## GWN76xx Firmware Release Notes

## [04/05/2024] FIRMWARE VERSION 1.0.25.18

GWN7660/GWN7660LR

- **Added L2TPv3 tunnel support.**

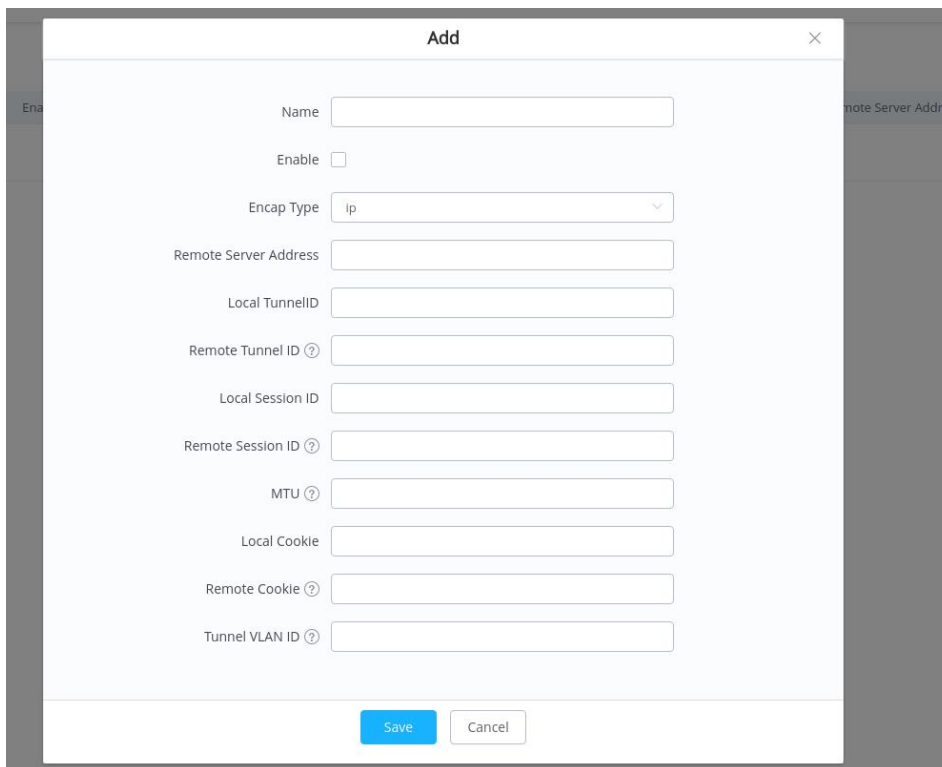
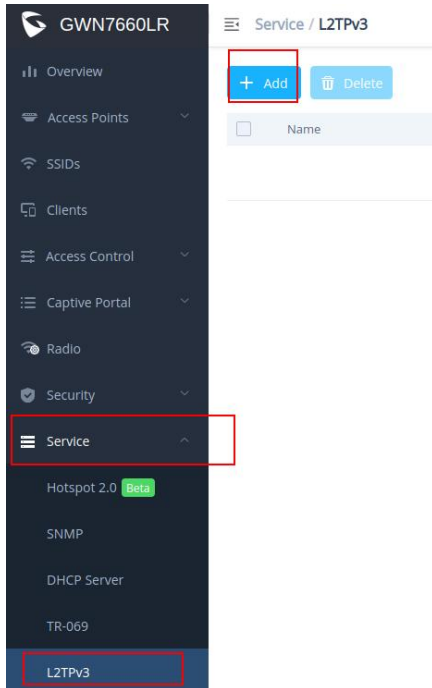
- Added **L2TPv3** tunnel support
- Internal bug fixes

This feature will allow admins to enable and configure L2TPv3 on the device. Please refer to the screenshots and options below.

Note: It is best to set the MTU to match the server to avoid network connectivity issues.

- **Name:** Set the name of the tunnel.
- **Encap Type:** Set the encapsulation type of the tunnel. Valid values for encapsulation are: UDP, IP.
- **Remote Server Address:** Set the IP address of the remote peer.

- **Local Tunnel ID:** Set the tunnel id, which is a 32-bit integer value. This uniquely identifies the tunnel.
- **Remote Tunnel ID:** Set the peer tunnel id, which is a 32-bit integer value assigned to the tunnel by the peer.

- **Local Session ID:** Set the session id, which is a 32-bit integer value. This uniquely identifies the session being created. The value used must match the peer\_session\_id value being used at the peer.

- **Remote Session ID:** Set the peer session id, which is a 32-bit integer value assigned to the session by the peer. The value used must match the session\_id value being used at the peer.

- **Local Cookie:** Set an optional cookie value to be assigned to the session. This is a 4 or 8 byte value, specified as 8 or 16 hex digits, e.g. 014d3636deadbeef. The value must match the peer\_cookie value set at the peer. The cookie value is carried in L2TP data packets and is checked for expected value at the peer. Default setting is no cookie used.

- **Remote Cookie:** Set an optional peer cookie value to be assigned to the session. This is a 4 or 8 byte value, specified as 8 or 16 hex digits, e.g. 014d3636deadbeef. The value must match the cookie value

set at the peer. It tells the local system what cookie value to expect to find in received L2TP packets. Default is no cookie used.

- **Tunnel VLAN ID:** The tunnel ID must be set in SSID, and make sure that SSID only has the AP(s) who enabled L2TPv3.
